NORTH AMERICAN—REPLACEMENT OF MAIN FUEL CELL DRAIN NIPPLE— P-51B, P-51C, AND P-51D

This Technical Order replaces T. O. No. 01-60J-27, dated 10 October 1944, revised to change the model of airplanes listed in paragraph 1. that will be modified by the contractor.

RESTRICTED
T. O. No. 01-60J-27

Figure 2
Fuel Cell
Drain Nipple

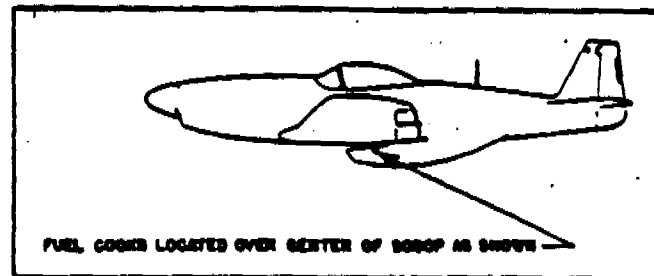
c. Remove the existing nipple, part No. 106-48255, which extends down from the drain casting in the wing to the inside of the air scoop. (See figure 2.)

d. Paint two red stripes, 1/2 inch wide, around the new type left- and right-hand nipples for identification,

since both the old type and new type nipples bear the same part number.

e. Install the new type nipples, part No. 106-48255, in the drain casting in the wing.

Figure 1 - Location of Main Cell Drain Cocks

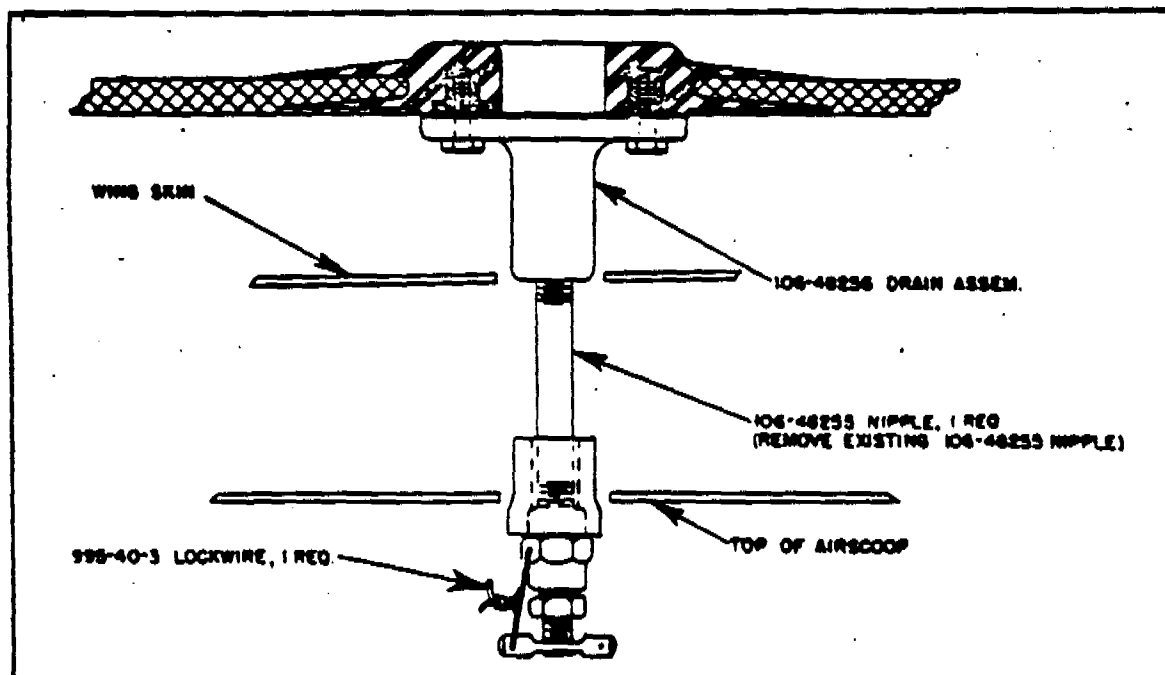
To prevent failure of the nipple in the main fuel cell drain assembly, with resultant loss of fuel and possible fire hazard, the currently installed nipple in the main fuel cell drain assembly on the following listed airplanes will be replaced with a heavier type nipple in accordance with the instructions contained in paragraph 2.

b. Remove the fuel drain cock, coupling nut, and protective hose from the bottom of the right- and left-hand nipple, part No. 106-48255, located inside the air scoop. (See figure 1.)
